Access Compliance Report Public Rights-of-Way (Curb Ramps)

Main Street: HIDDEN CREEK DR **Cross Street: MOSS STREAM LN** Location: Intersection ID: 30214 NE ADA ID: 7F5D3334DC5B Ramp Type: BlendTrans1 Initial Pass/Fail: Fail **Overall Compliance: No** 10 **Severity Score:**

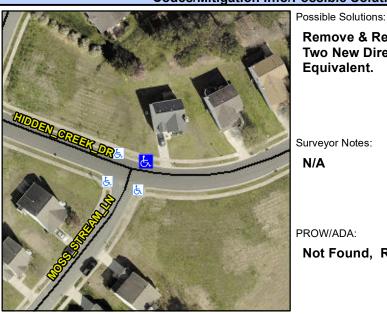
BlendTrans Slope (%)

BlendTrans XSlope (%)

Two New Directional Ramps or Equivalent. Surveyor Notes: N/A
